DEPARTMENT OF TRANSPORTATION AND ENVIRONMENTAL SERVICES  
Division of Environmental Quality  
P.O. Box 178 – City Hall  
Alexandria, Virginia 22313  
<http://alexandriava.gov/tes/DEQ/>

**Re: Proposed Merged-Stack Stationary Source Permit to Operate Dated December 21, 2007, Mirant Potomac River Generating Station, Alexandria, Virginia**

### Summary of Alexandria's Comments

**Average Stack Opacity With and Without Trona Use**

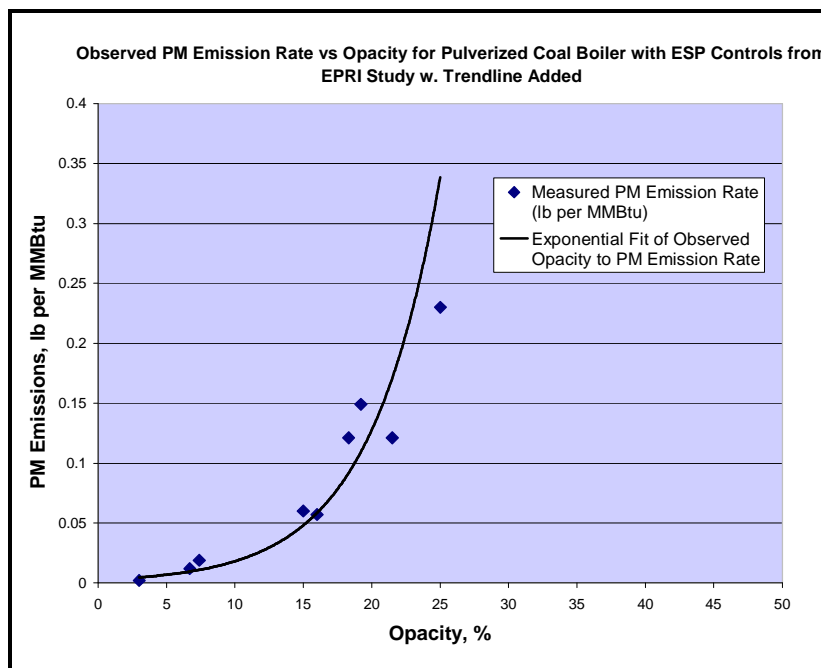
Alexandria has analyzed several months of opacity data from all five boilers at the PRGS. The data reflect actual in-stack Continuous Opacity Monitoring System (COMS) readings during operations both with and without the use of trona. The following table shows that in-stack opacity increased for every boiler due to the use of trona by as much as 110 percent. Given that opacity is an indicator of particulate matter emissions, especially fine particulate matter, Alexandria believes that trona contributes to PM emissions increases.

The figure below shows a curve fit between observed emission rates and opacity for testing of a pulverized coal boiler, obtained by Electric Power Research Interest Group, and reported by U.S. EPA.<sup>13</sup> These data clearly show that opacity positively correlates with PM emissions. Of particular concern to Alexandria is the fact that opacity is closely related to fine particulate
